**Re: Pacific Northern Gas Ltd. and Pacific Northern Gas (N.E.) Ltd.  
Application for Acceptance of 2019 Consolidated Resource Plan and for Acceptance of  
Energy Conservation and Innovation (ECI) Portfolio Funding for 2020 and 2022  
Response to BCSEA Information Request No. 1**

**REQUESTOR NAME:** BC Sustainable Energy Association  
**INFORMATION REQUEST:** No. 1  
**TO:** Pacific Northern Gas Ltd. and  
Pacific Northern Gas (N.E.) Ltd.  
**DATE:** February 6, 2020  
**PROJECT NO:** 1599056  
**APPLICATION NAME:** Application for Acceptance of 2019 Consolidated Resource  
Plan and for Acceptance of Energy Conservation and  
Innovation (ECI) Portfolio Funding for 2020 and 2022

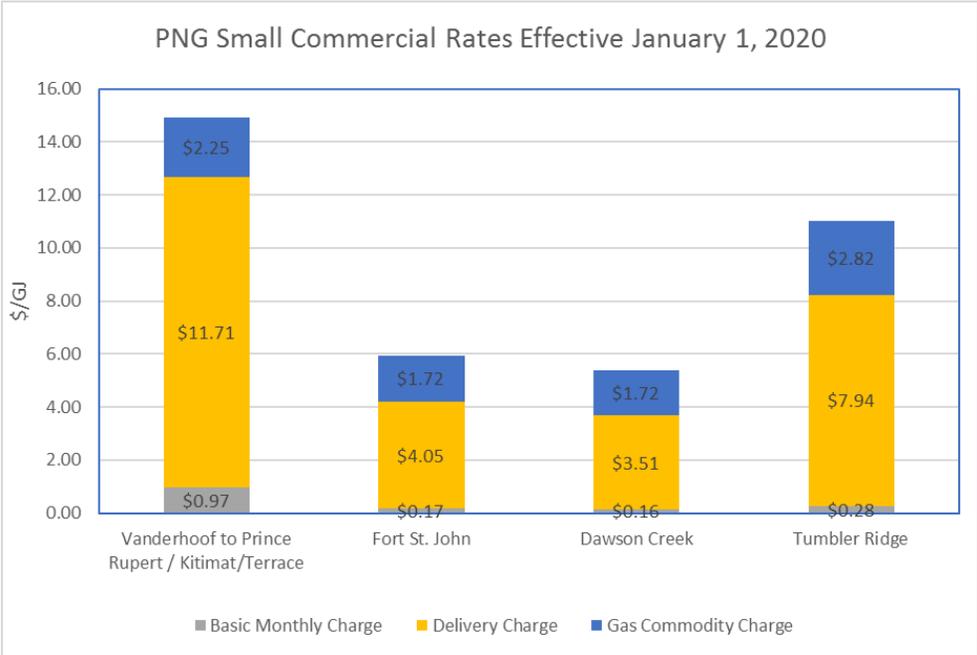
4.2 Please provide a summary graphic and table illustrating the differences in rates between the various service areas, by rate class.

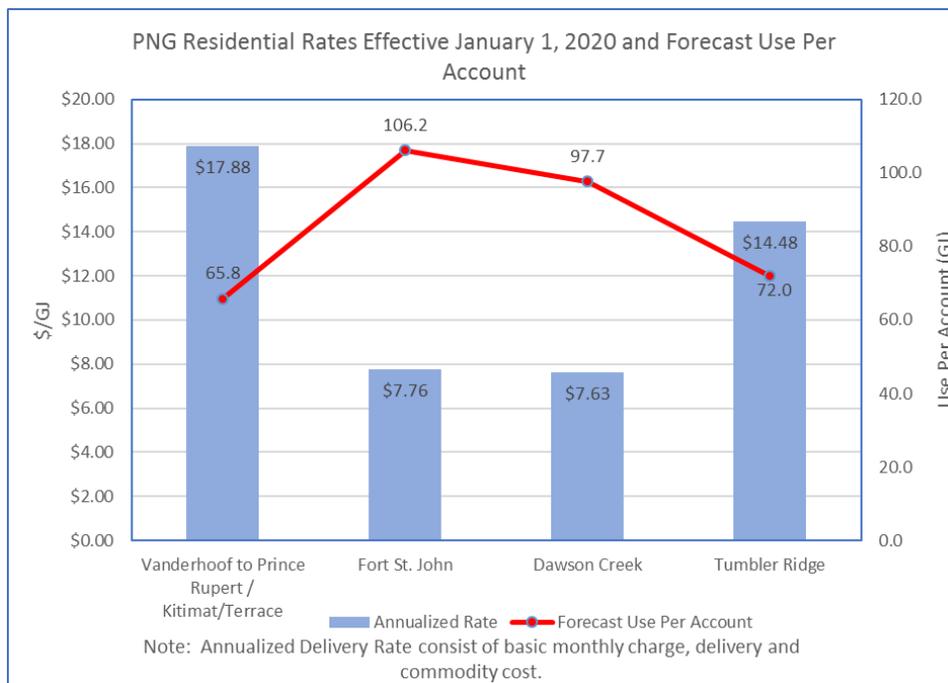
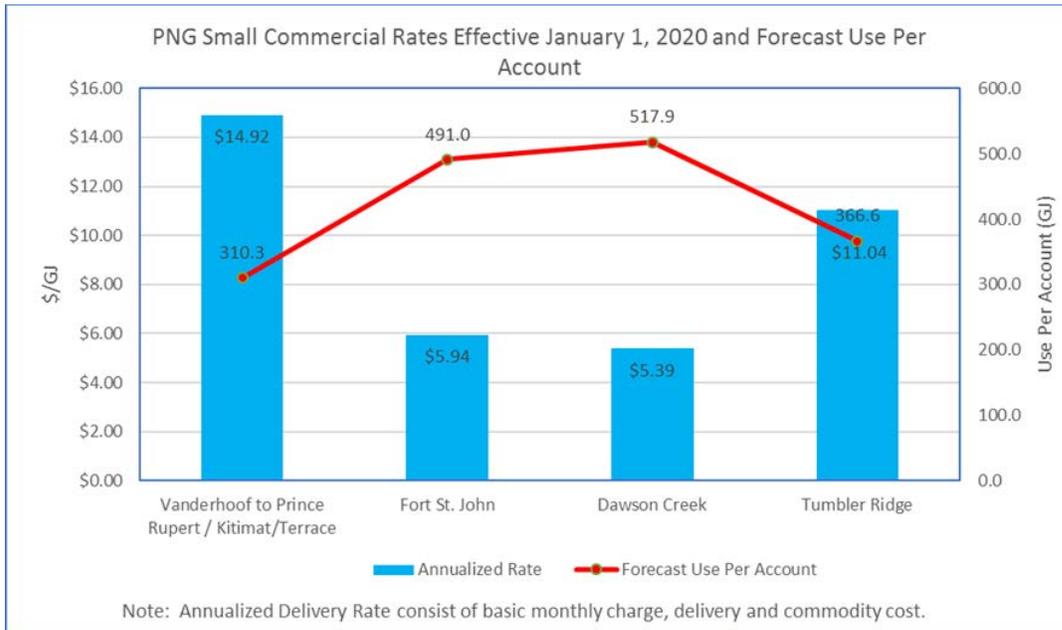
4.3 For each of the rate classes, please provide a summary graphic and table illustrating Use per Account and rates for each of the service areas.

Please see the table and graphs that follow. The annualized rate includes the delivery and commodity charges, as well as 12 monthly fixed charges divided by the forecast annual use per account.

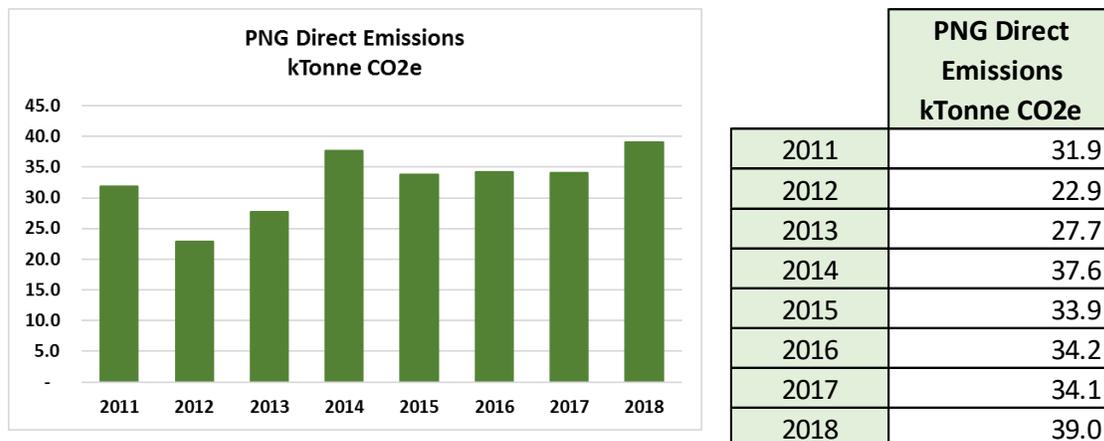
16.1 Please provide a graph and table showing PNG’s aggregated direct GHG emissions (in tCO<sub>2</sub>e and as a percentage of total) by year for the years for which data is available. Please note any assumptions, such as changes in the CO<sub>2</sub> equivalence of methane.

Please see the table and chart that follow.

PNG’s GHG emissions have been stable over the past 8 years. There are some contributions to PNG’s direct emissions that PNG can not control such as 3rd Party Damages which deviate significantly from year to year. The main difference in GHG emissions in recent years has been an increased amount of repairs to PNG’s high pressure pipelines following analyses from inline Inspection tool runs. Whenever a cutout is performed, the gas from a section of mainline is evacuated to atmosphere (blown down), releasing methane. As the amount of cutouts has increased so too have the emissions from blow downs.

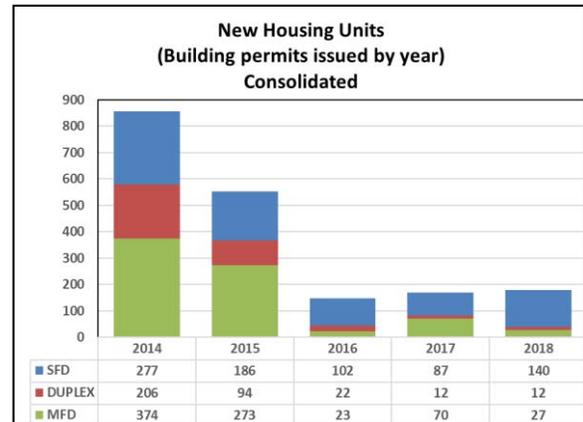
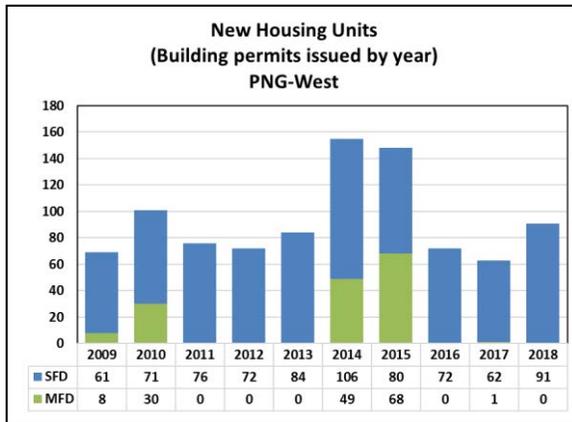
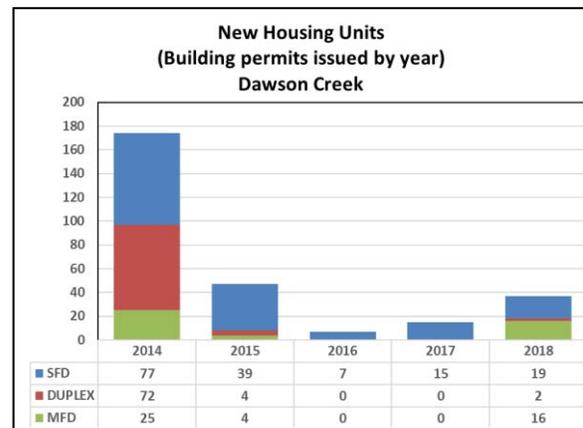
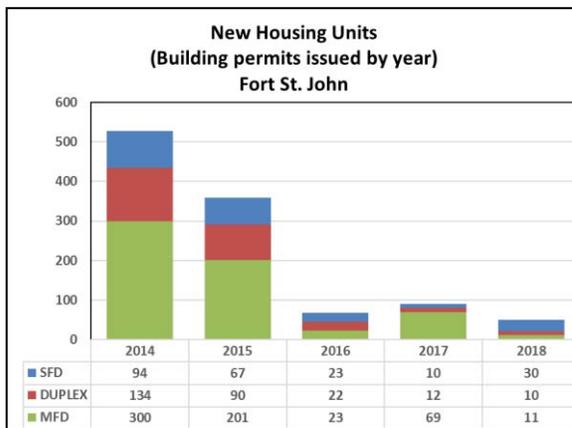
22.4 Please provide a version of Figure 19 and Figure 20 showing New Housing Mix by number for Fort St John, Dawson Creek, PNG-West, and consolidated.

Please see the charts, below.

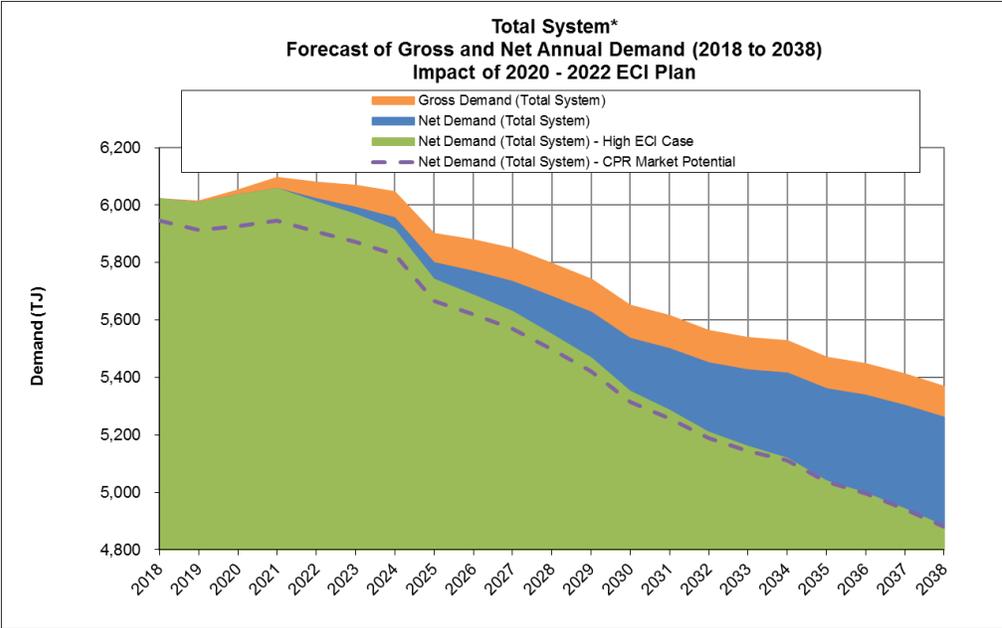
35.3 In Figure 64: Forecast Gross and Net Annual Demand (TJ), what is the dashed purple line?

Please see the revised version of Figure 64, below. PNG has corrected the formatting error in Figure 64. The dashed purple line indicates the total net system demand if the market potential savings identified in the 2017 Conservation Potential Review were realized.

Figure 5-17. Top 40 Measures for Gas Energy Market Savings Potential in 2025 (TJ/year)

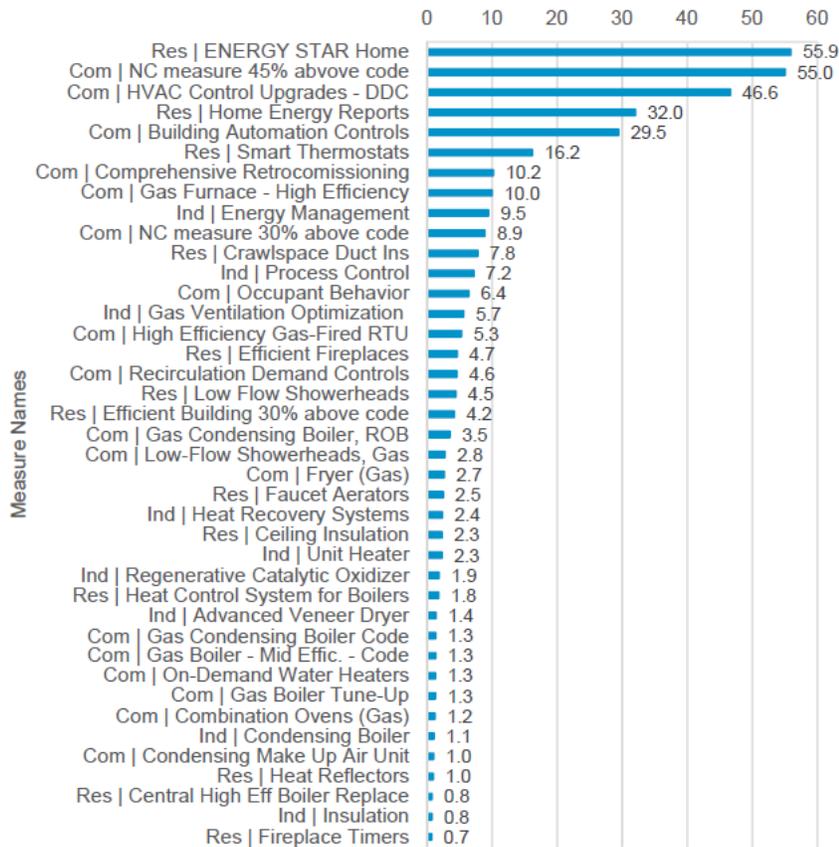
- 43.1 Please reproduce Figure 5-17 showing the top 40 measures for the economic potential.
